**SAN ANTONIO WATER SYSTEM  
DOS RIOS WRC RE-RATING  
HEADWORKS IMPROVEMENTS AND  
PROCESS ENHANCEMENTS PHASE I  
SAWS Job No. 08-6502  
SAWS Solicitation No. B-10-057-DD**

**ADDENDUM No. 3  
December 9, 2010**

SHEET MB-1 – INFLUENT SCREENING FACILITY TOP PLAN AT EL. 493.00

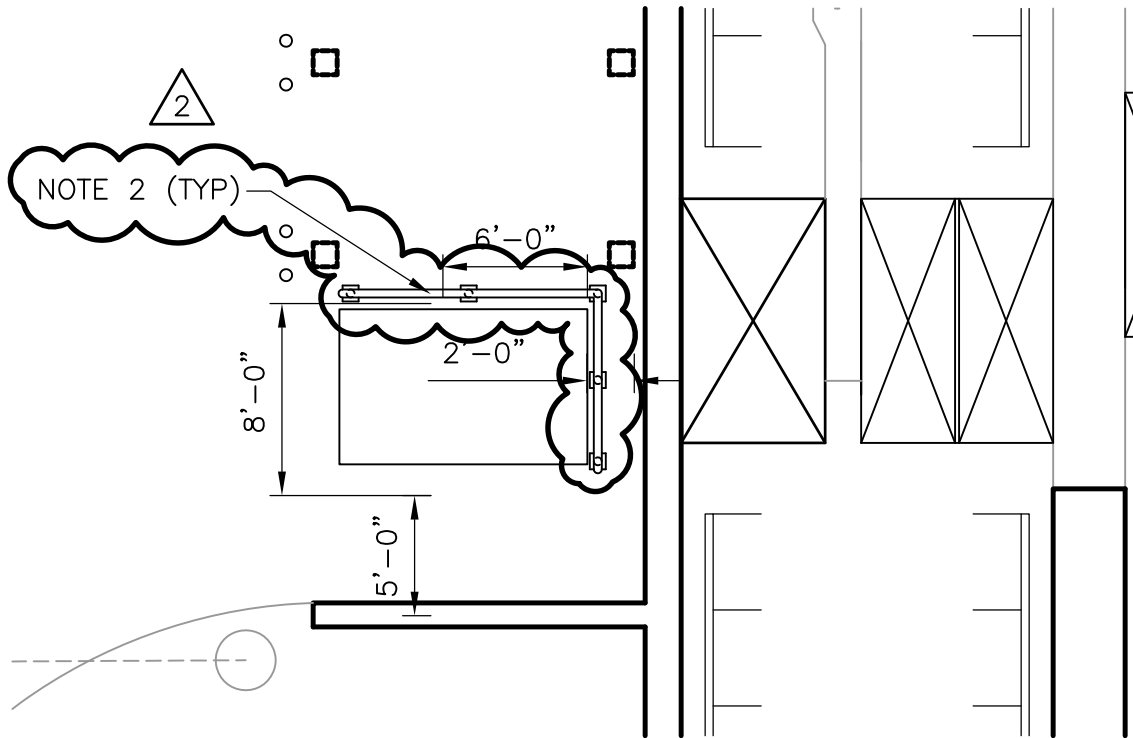
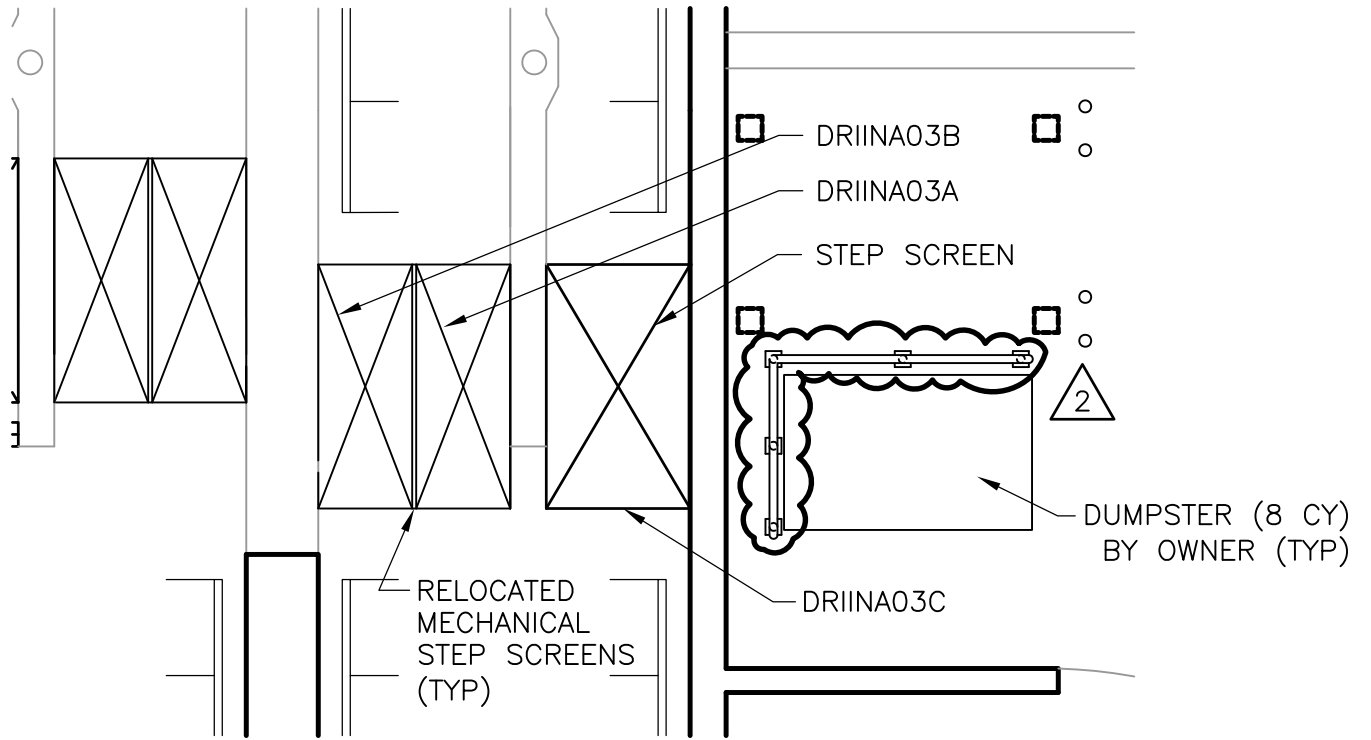
**Q56. Refer to Sheet MB-1. There are notes saying “Relocated Modified Conveyors”. What modifications are to be done to the existing conveyors?**

- a) Revise sheet as shown in Exhibit MB1-A.

A56. All necessary modifications shall be made to coordinate location of the conveyor discharge chute with the compactor inlet. Also, controls for the compactors shall be modified.

**DETAIL** **BG**

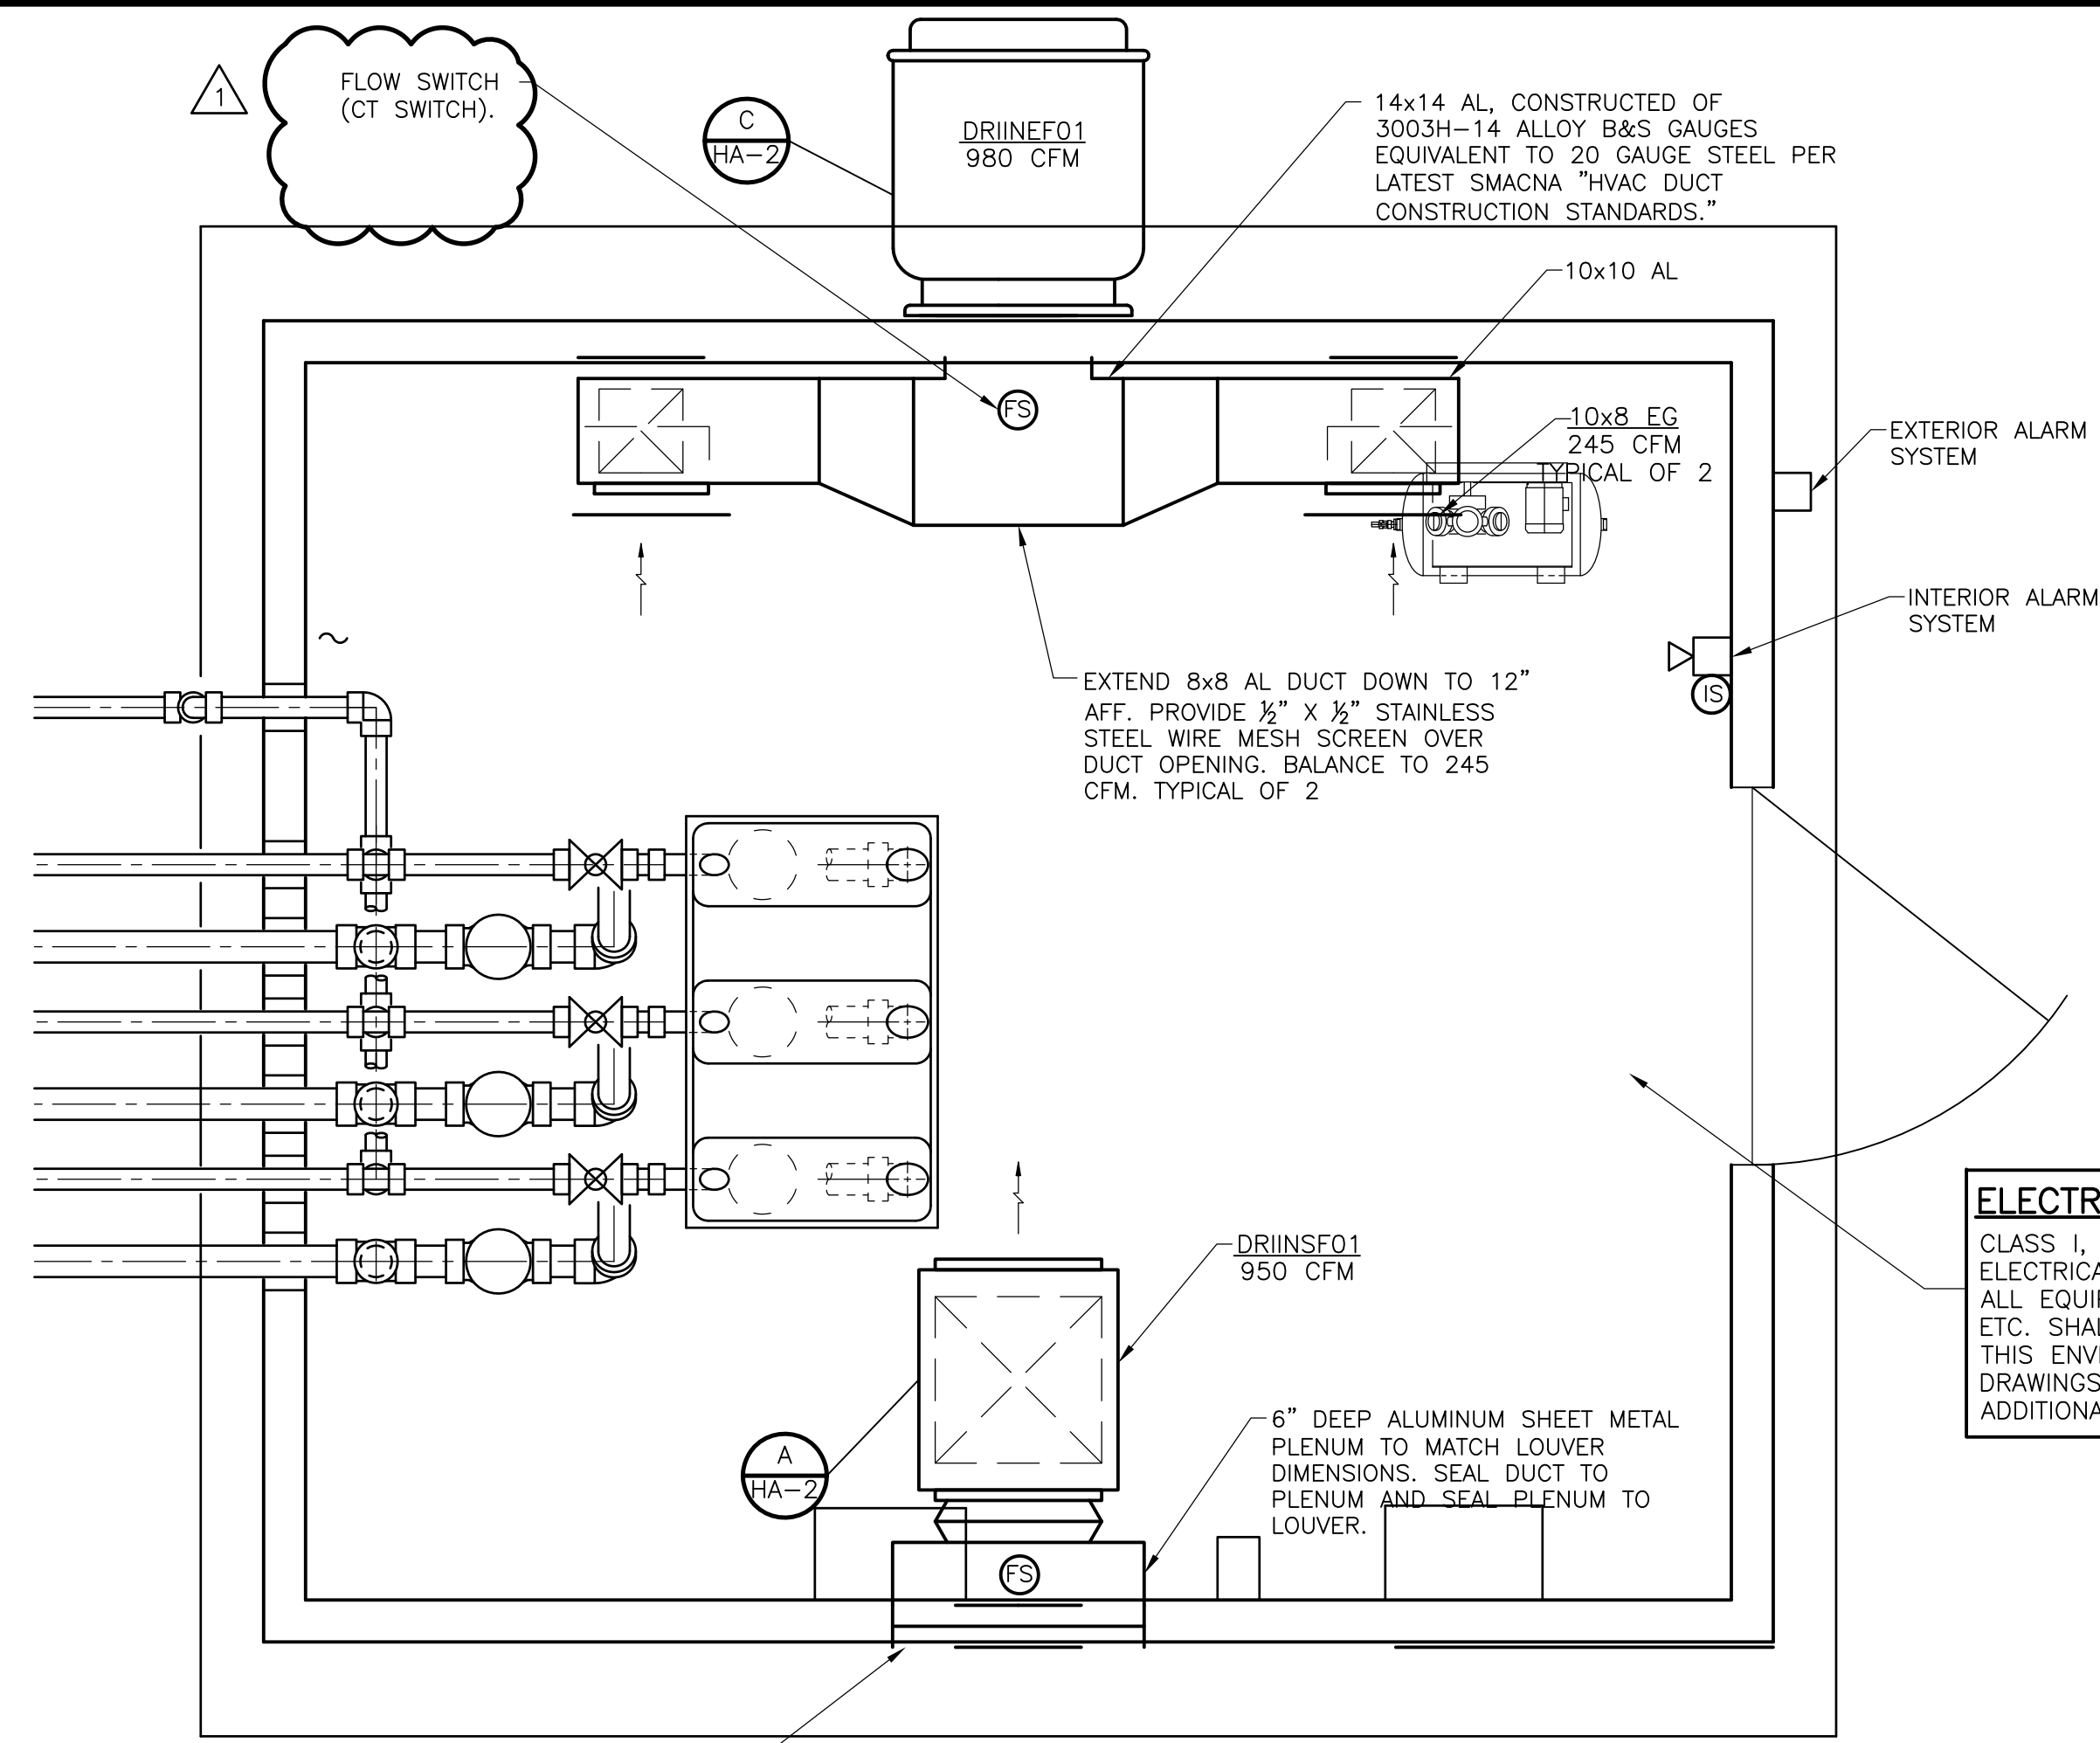
**Q16. Can you be more specific on which nozzle you want as per Detail BG/MZ-2? I can't find a nozzle in Seal Fast's catalogue that will work with a 1" yard hydrant (as per Detail BF/MZ-2).**

SHEET MZ-2 – MECHANICAL DETAILS II

- A16. As part of this addendum, more detailed information has been added to Detail BG/MZ-2.
- Q17. Note 13 on Sheet E-2 calls for ductbank to be demolished. Can drawings of existing ductbank be provided so that the size and type of cables in this ductbank are known?**

- NOTES:**
1. PROVIDE 1" MALE QUICK DISCONNECT ADAPTER AND REDUCING BUSHING (IF REQUIRED) FOR FLUSHING CONNECTION TIE-IN ON CHEMICAL FEED EQUIPMENT AND OTHER. QUICK DISCONNECT ADAPTER SHALL BE PVDF MATERIALS AS MANUFACTURED BY THE DYMAX GROUP, PLEASANTON, CA, OR EQUAL.

SHEET HA-2 – INFLUENT FLOW METERING FACILITY – HVAC PLANS, SECTION AND DETAILS

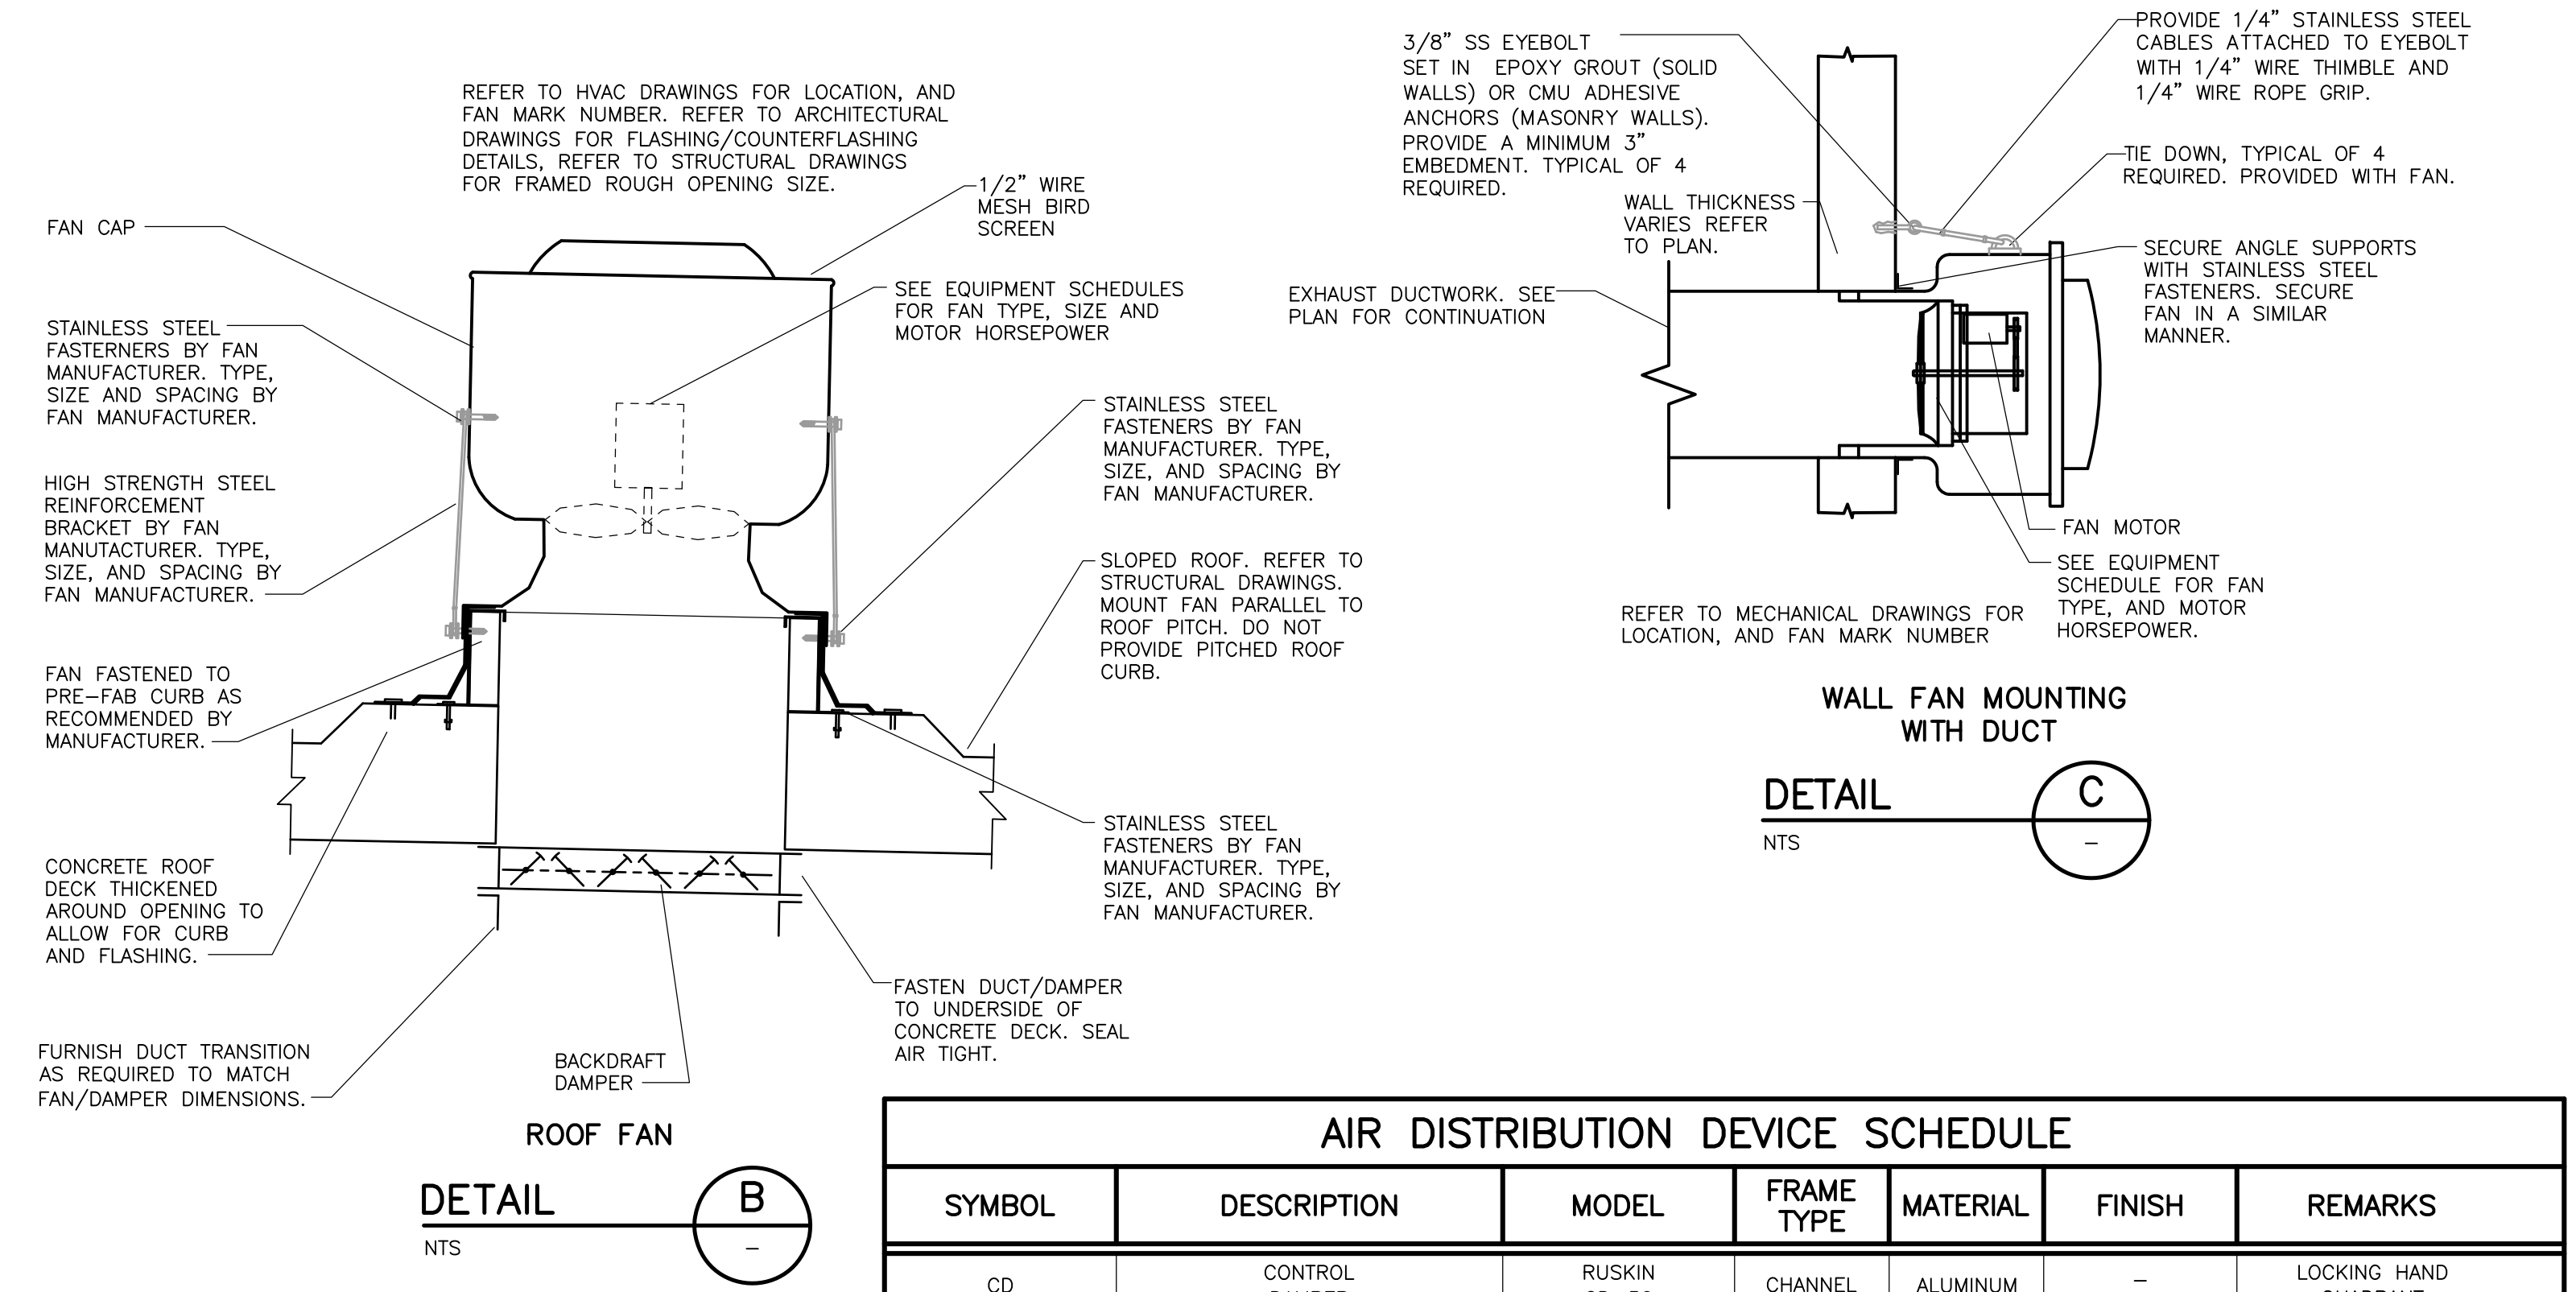
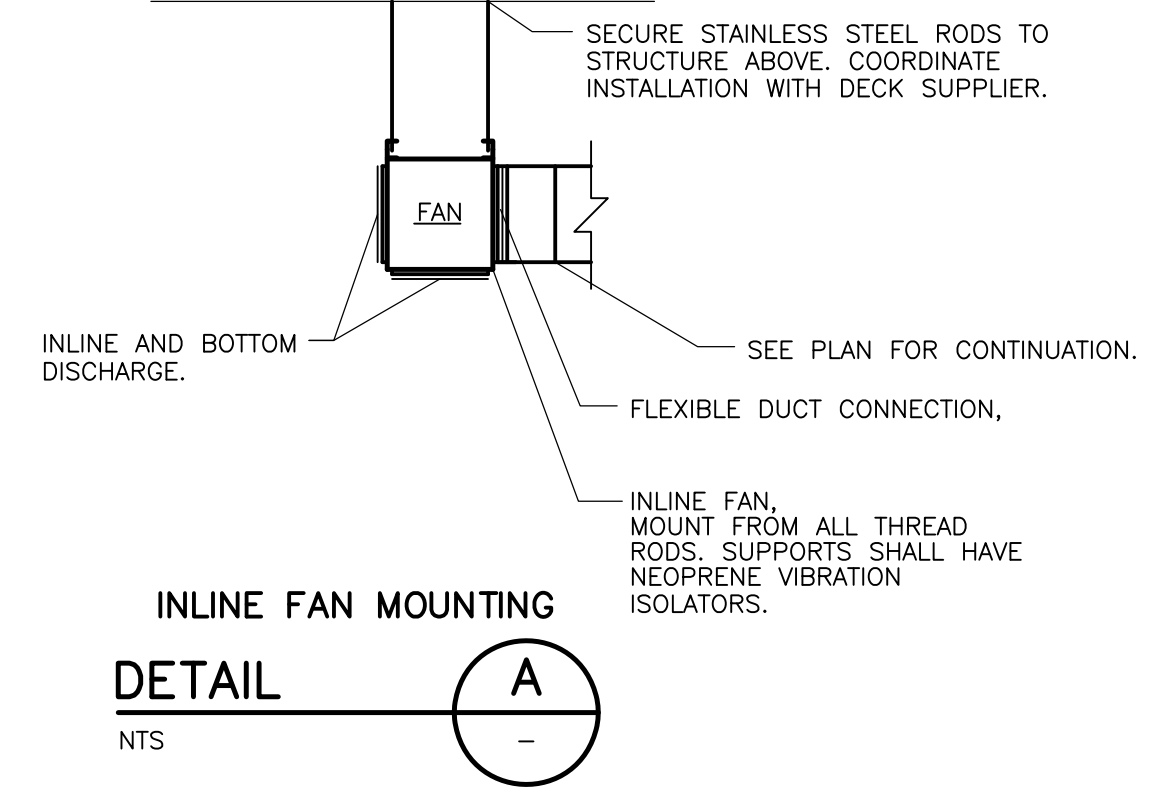
**Q51. On Sheet MA-1 (from Addendum No. 1), we see “DRIINEF03” exhaust fan shown but there is no scheduled information (e.g., CFM, static pressure, etc.) that we have seen.**

A51. Fan schedule is included on Sheet HA-2. As part of this addendum, the fan tag number on Sheet HA-2 has been updated to match that shown on Sheet MA-1.
